ADDENDUM NO. 2

DPW Project #2023256

April 30, 2024

**DPW/UI – Ag Science Building HVAC Phase Two
University of Idaho
Moscow, Idaho**

SHEET
M3.52A

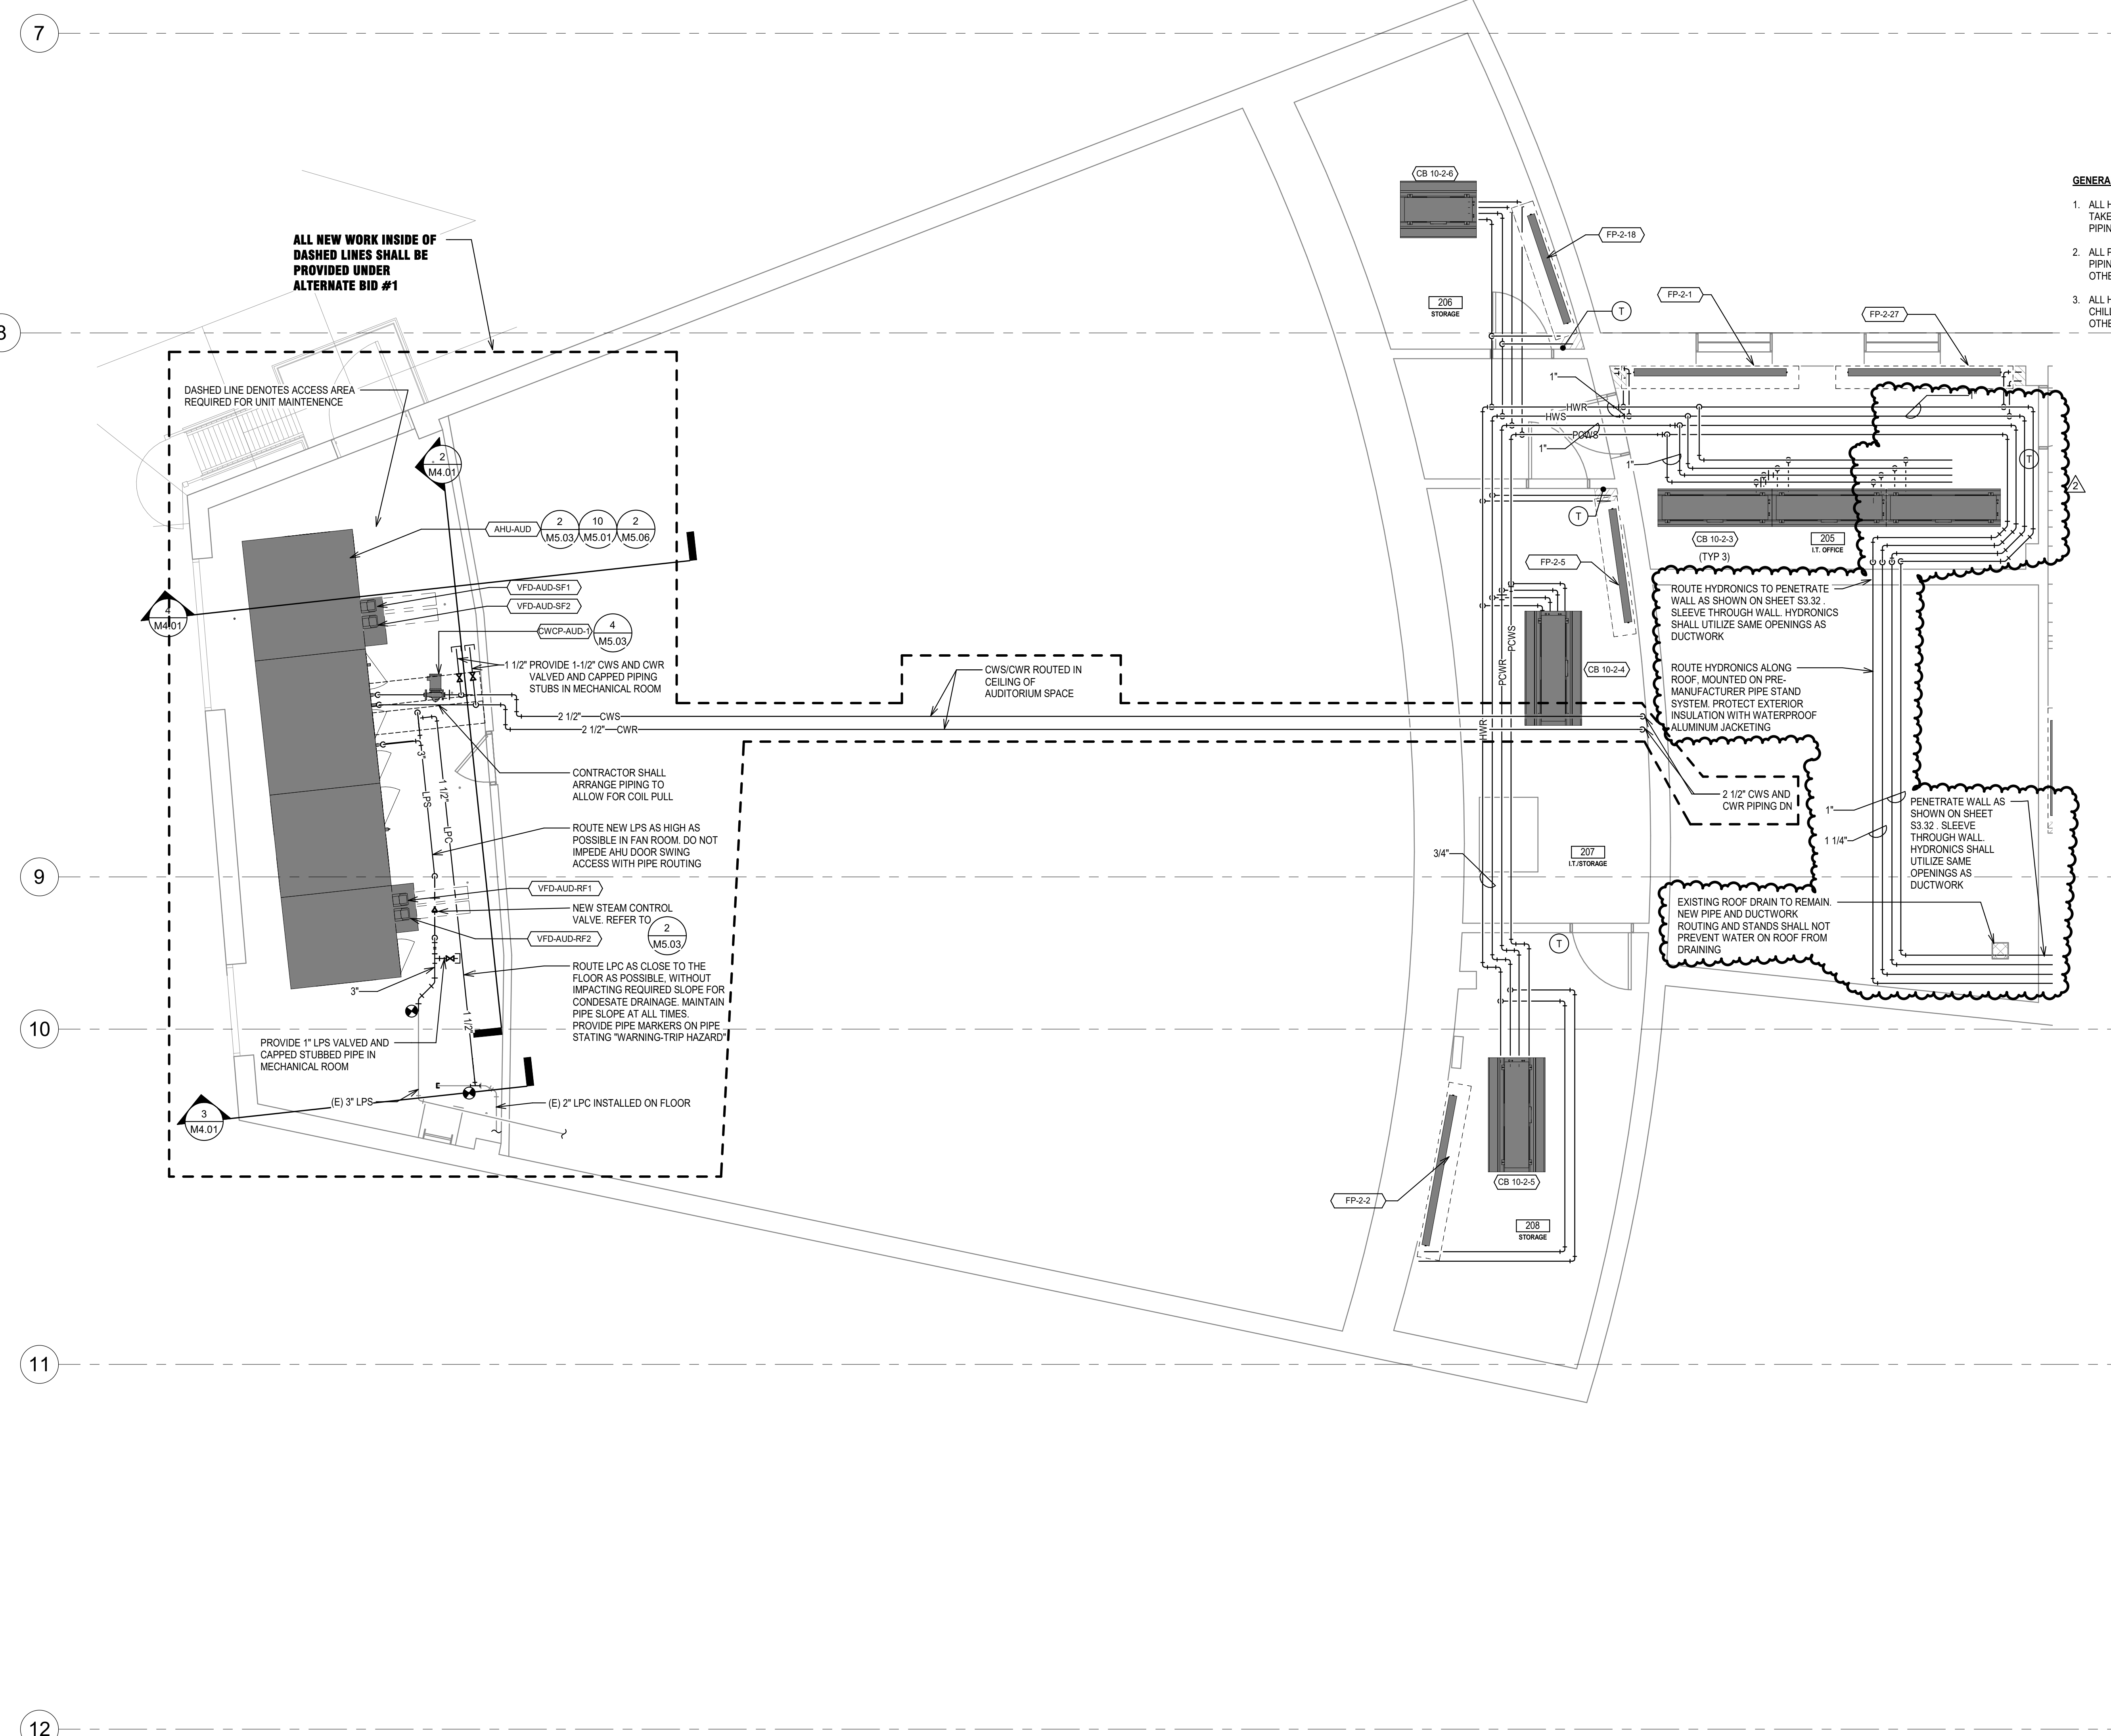
- 2.43 M3.52A- SECOND FLOOR AREA A - HYDRONICS**
REVISION: See attached drawing for revised piping routing and terminal unit placement for coordination.
